Subject: Limerick Generating Station, Units 1 and 2
Safety Evaluation Report Open Issue Nos. 17 & 18
from NRC Licensee Qualification Branch (LQB)

Enclosed are draft FSAR changes developed as a result of the reference conference calls which we believe will resolve open review issue nos. 17 and 18, as described in the Limerick Safety Evaluation Report (NUREG-0991).

LIMERICK GENERATING STATION UNITS 1 AND 2 FINAL SAFETY ANALYSIS REPORT

FIGURE 13.5-1

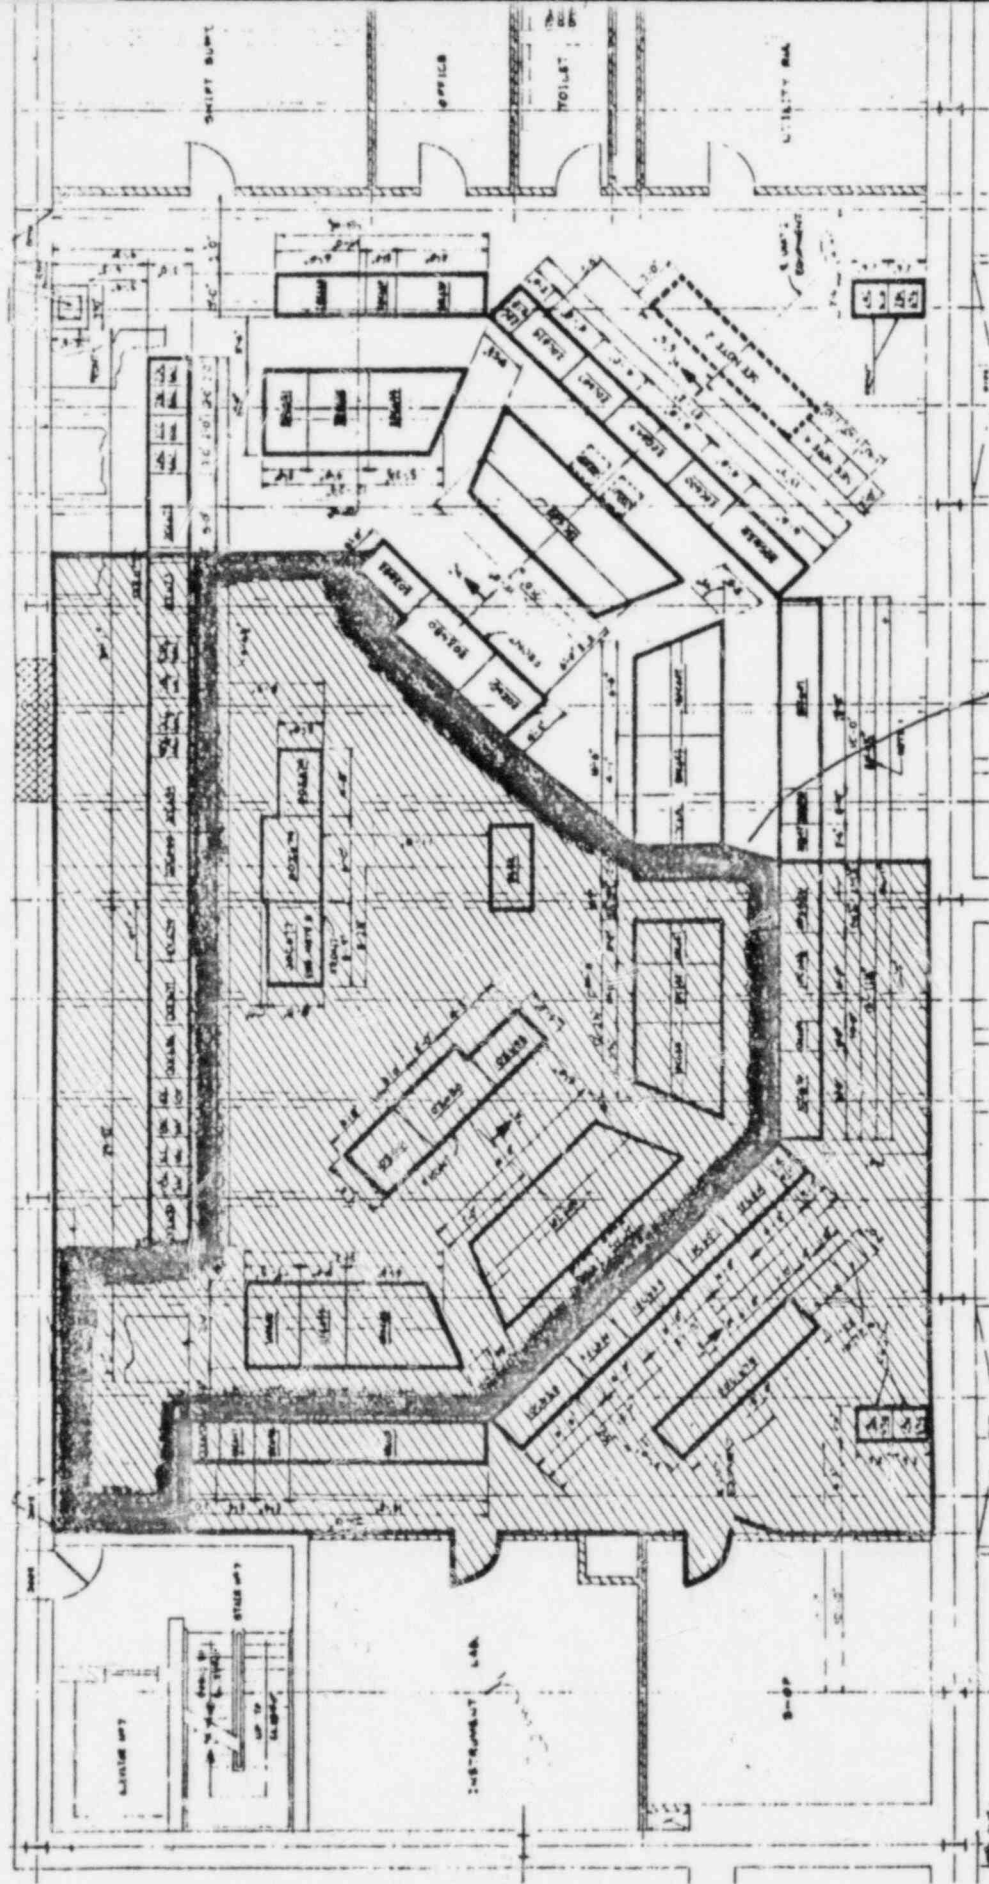
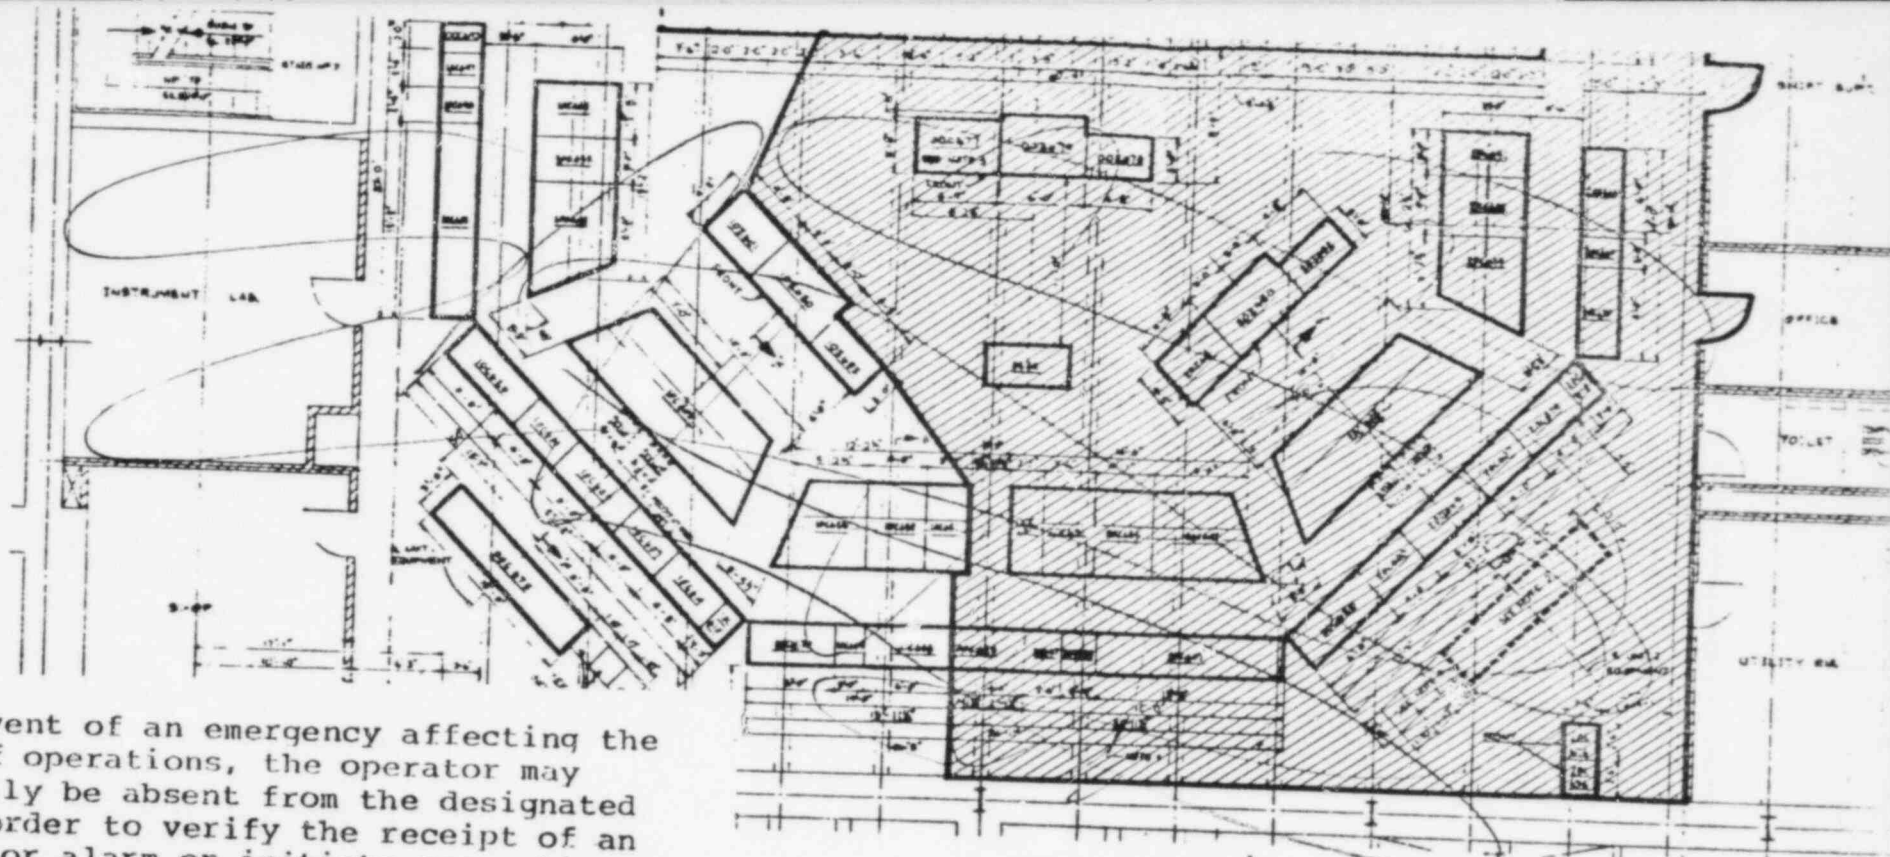
*see next
15 for revised
shaded area*

red line shaded area
to within dashed
outline.

FIGURE 135-1

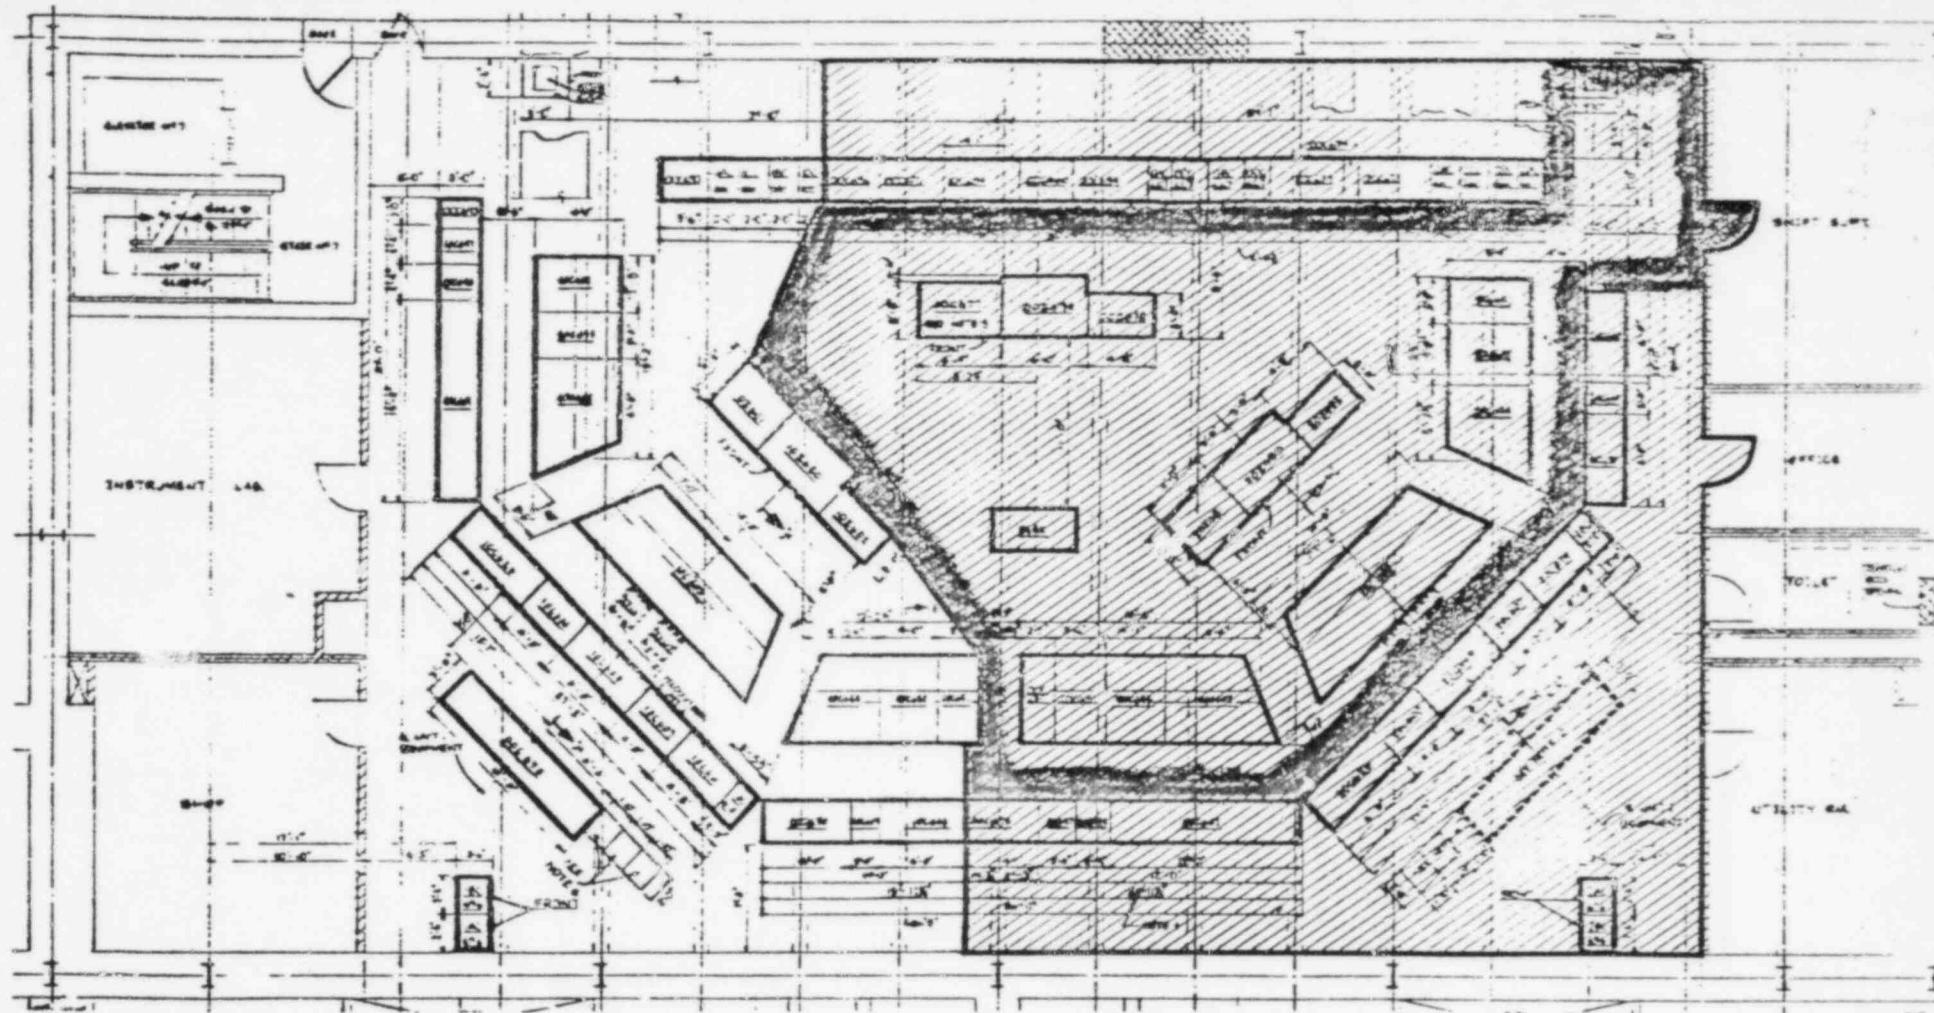
*seduce shaded area
to within darkened area.*

FIGURE 13.5-2

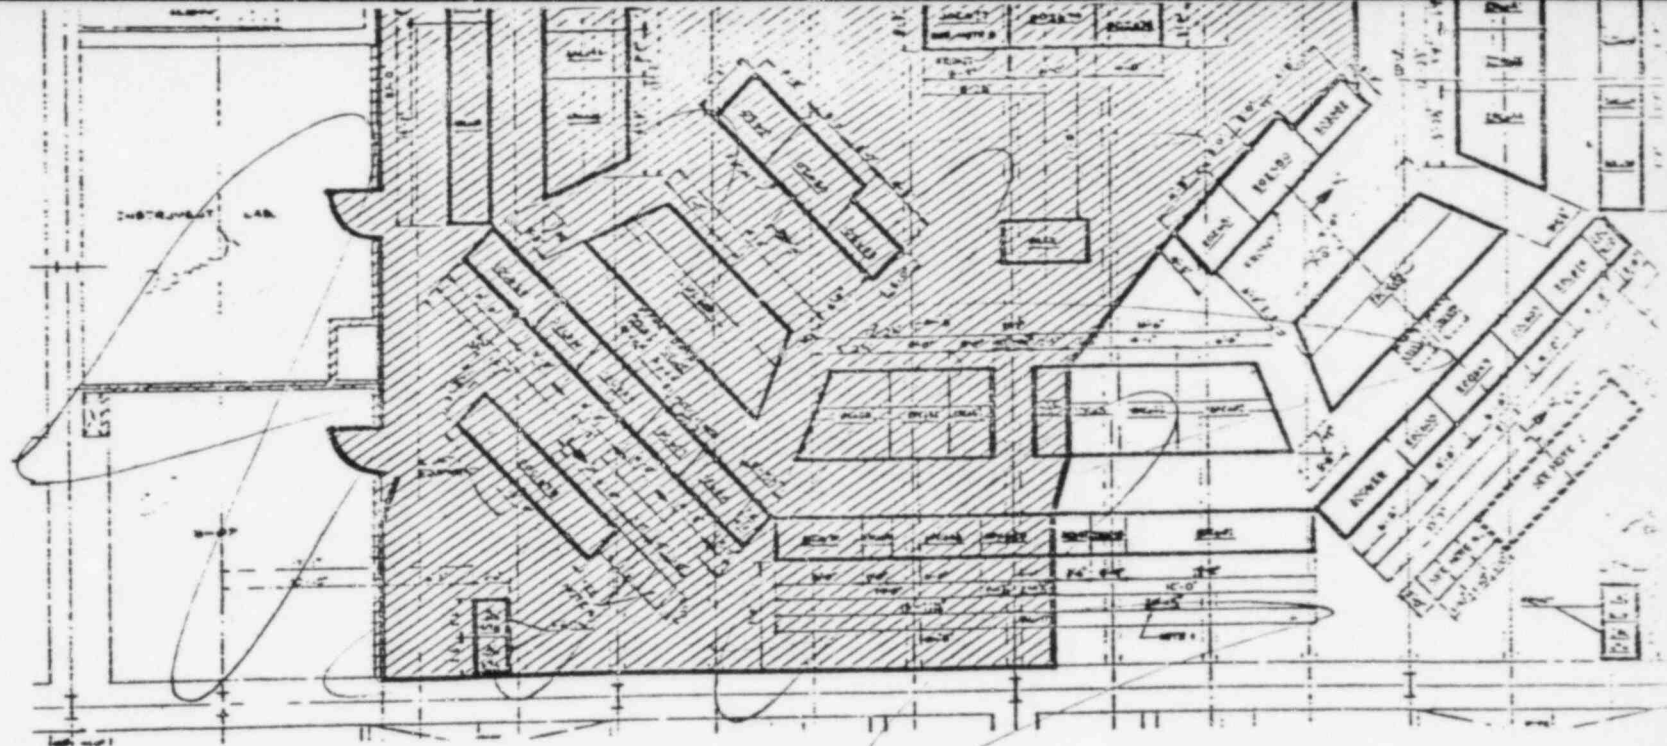
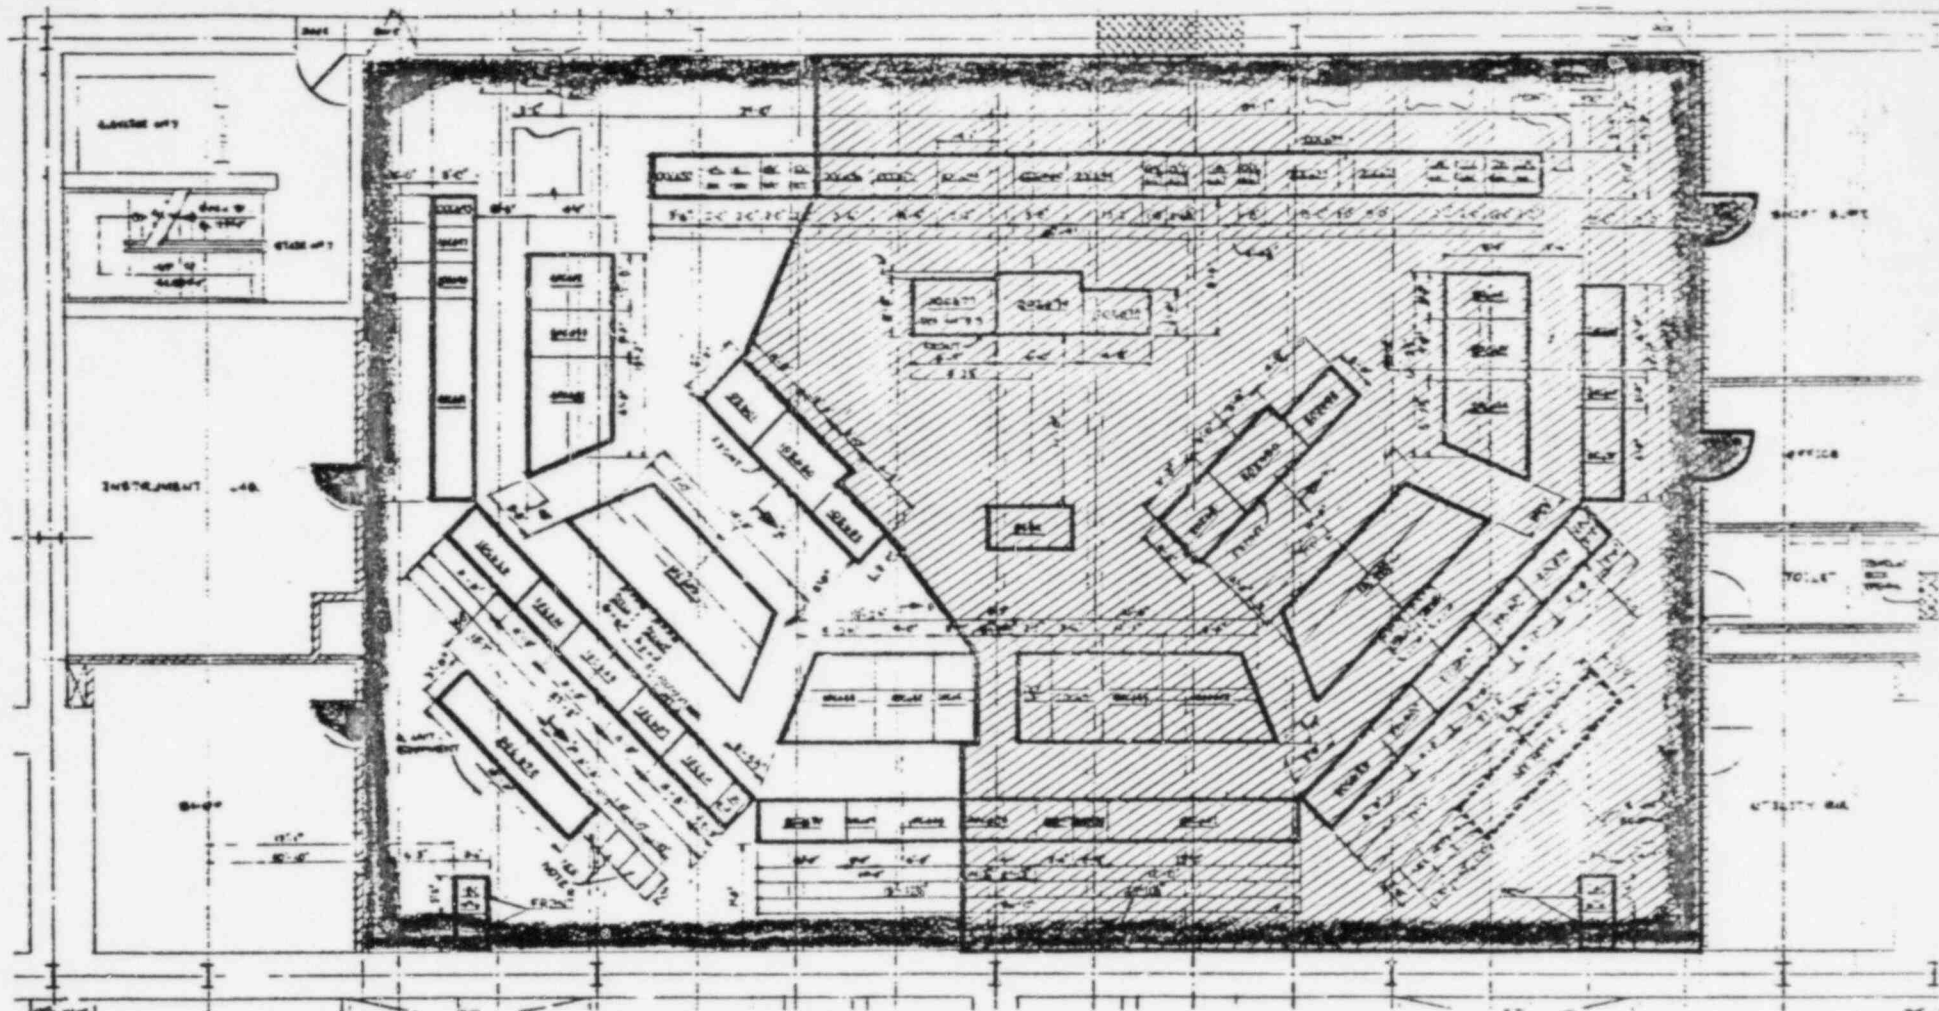
see
next pg
for shaded area.

- (1) Only control panels associated with the operation of that unit or common unit panels are included inside the defined boundary. If, in the future, panels are added to the control room, they are necessarily included in the definition of "at the controls" for that unit. Office, utility, or rest facilities are not included in the defined boundary with the following exceptions: ~~The unit 2 operator may open the Shift Superintendent or adjacent office doors for verbal communication as long as he remains in the area circumscribed by the door and the door is held open. The same situation applies to the unit 1 operator and the instrument lab and shop doors, as indicated.~~

- (2) ~~Normal "at the controls" locations do not apply during any condition during which the control room is not habitable. In that event, the "at the control" location is the Emergency Shutdown Panel for that unit.~~

shaded area
with dashed outline
new fig. 13.5.2

The SRO

instrument lab, and shop

SRO Control Room Boundary DEFINITION OF "AT THE CONTROLS"
